ITEM FOR ENVIRONMENTAL COMMISSION AGENDA

NAME & NUMBER OF PROJECT: 3801 Westlake
SP-2019-0243DS

REQUEST: Variance request is as follows:
Request to vary from LDC 25-8-281(C)(2)(b) to allow construction
of a boat dock and shoreline access within a 150-foot Critical
Environmental Feature (CEF) buffer for a Rimrock CEF.

Development Services Department
Staff Recommendations Concerning Required Findings

3801 WESTLAKE DRIVE
PROPOSED CONDITIONS SITE PLAN
AND EROSION CONTROLS SHEET

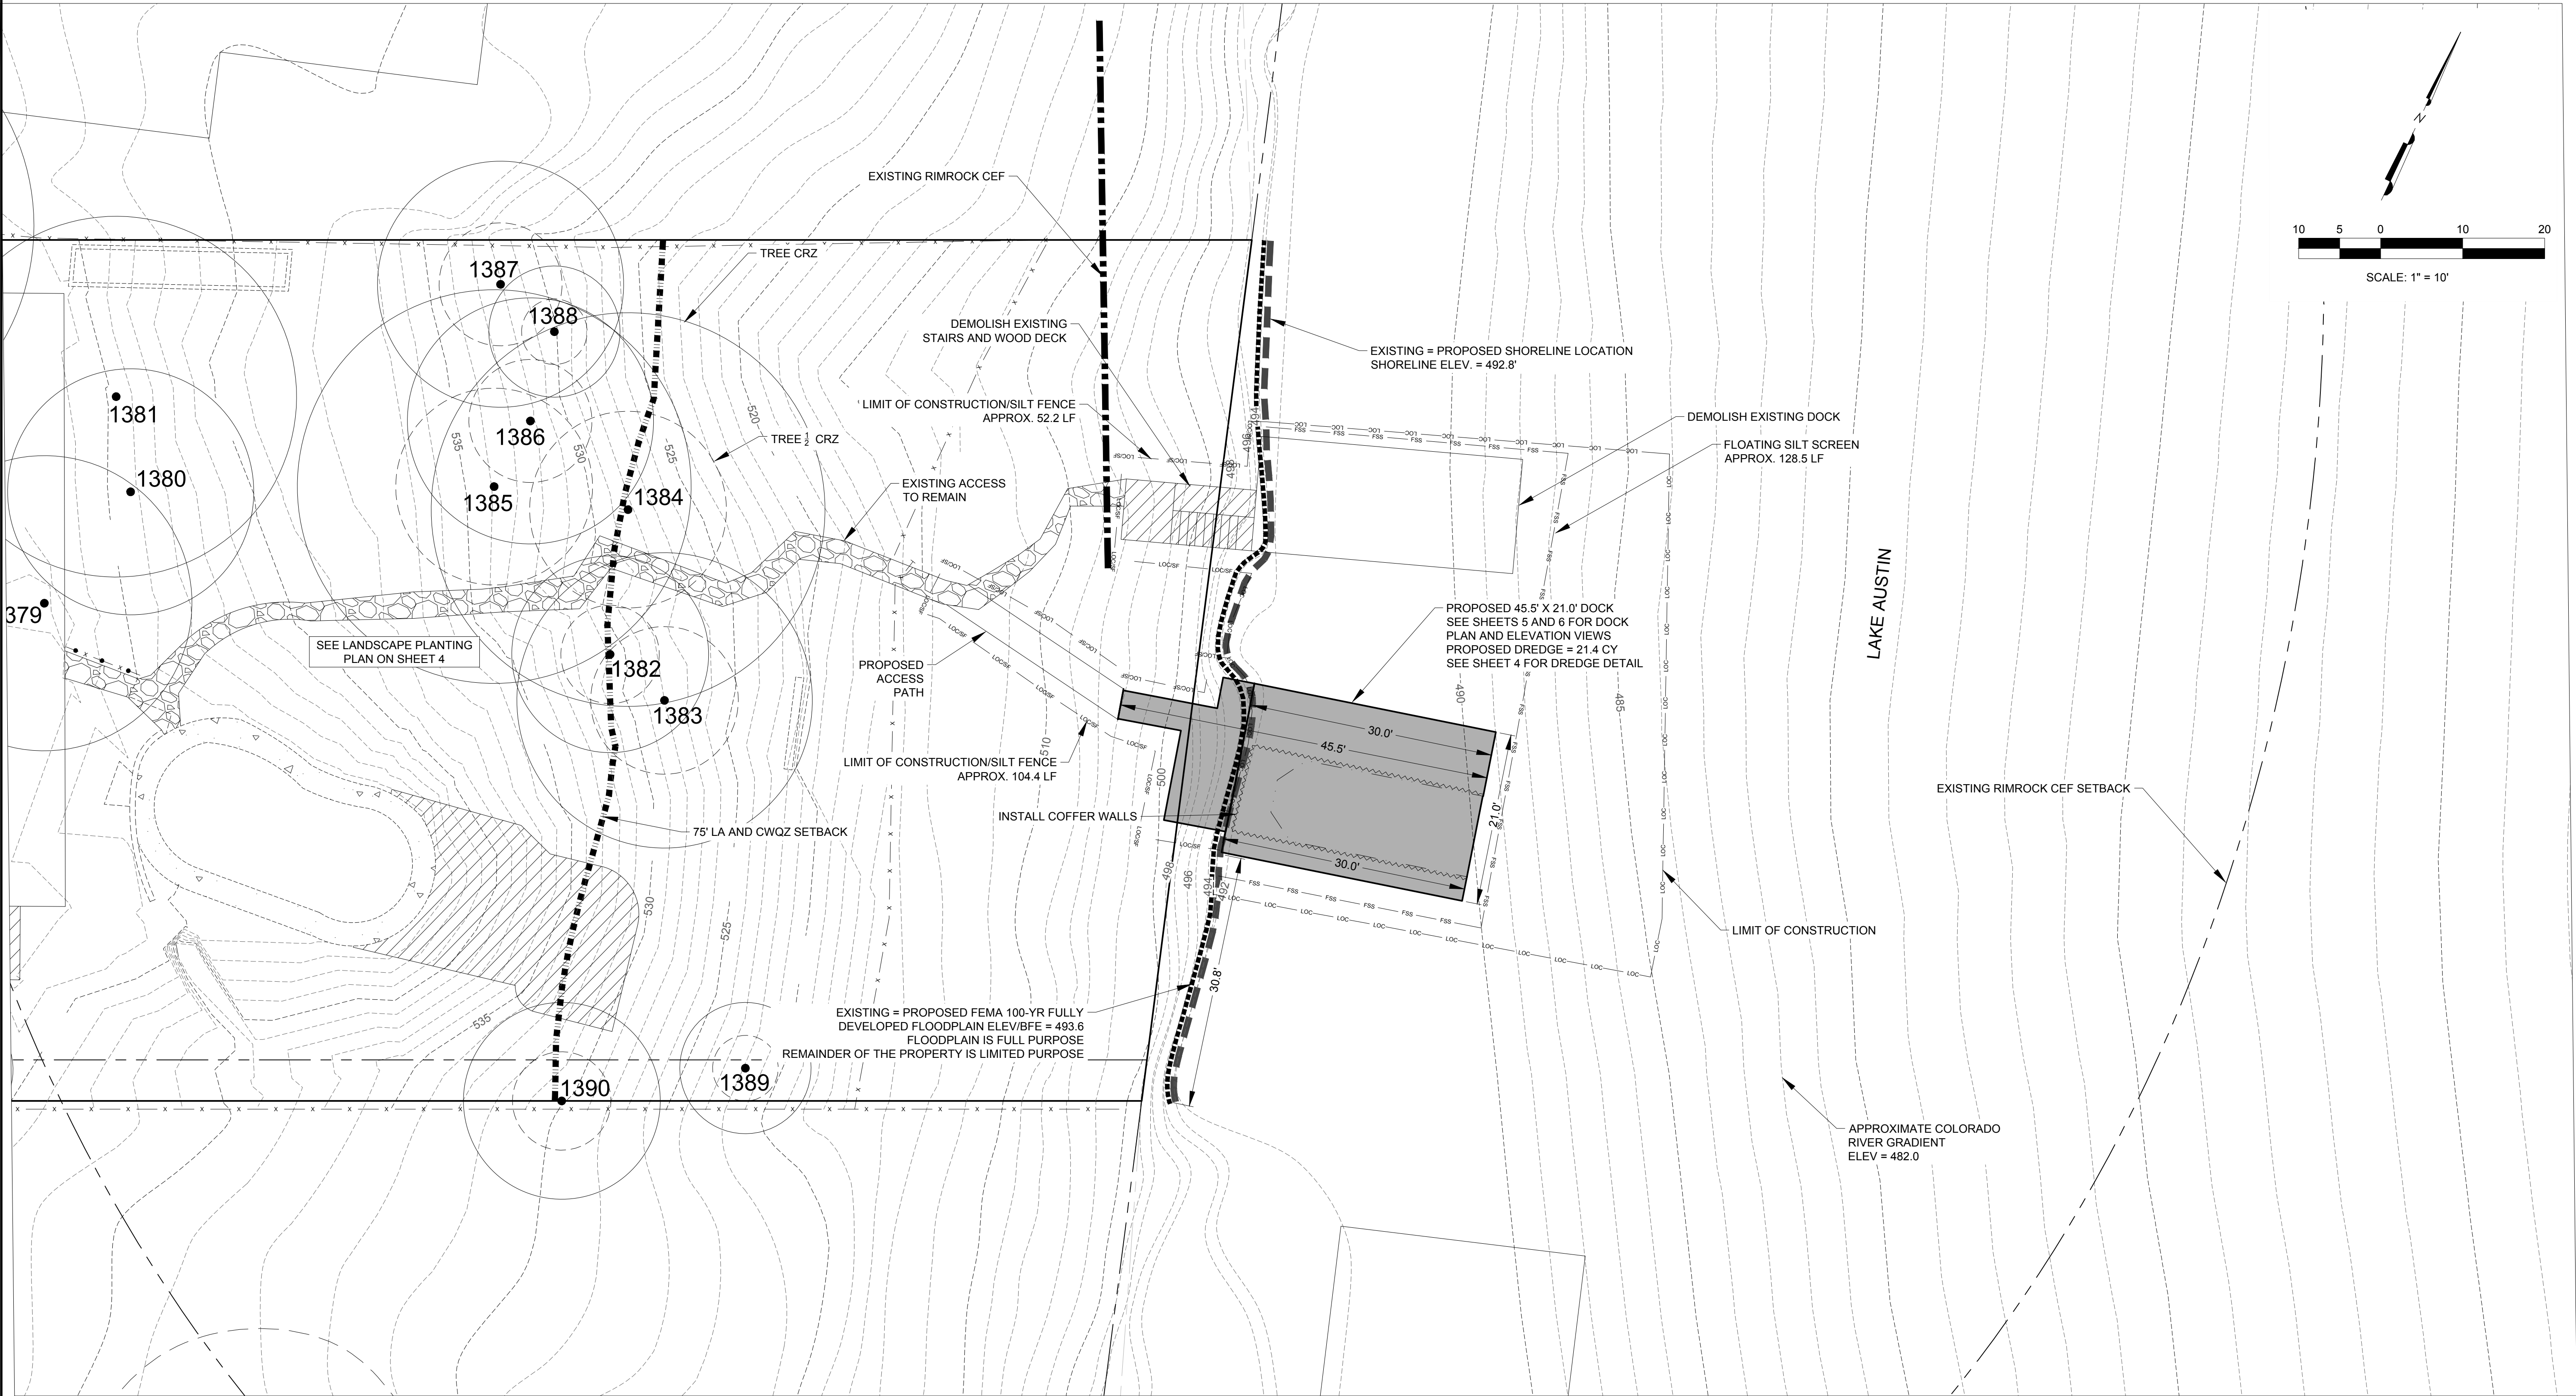
1. The portion of the existing access path that will be bypassed, between the point where the new path will branch off from the existing path and the endpoint of the current path where it connects with the current bridge, shall be removed and revegetated.
2. In the plan set, a non-erodible surface (e.g., paving, shallow stairs, etc.) for the proposed path shall be specified.

1. The portion of the existing access path that will be bypassed, between the point where the new path will branch off from the existing path and the endpoint of the current path where it connects with the current bridge, shall be removed and revegetated.
2. In the plan set, a non-erodible surface (e.g., paving, shallow stairs, etc.) for the proposed path shall be specified.
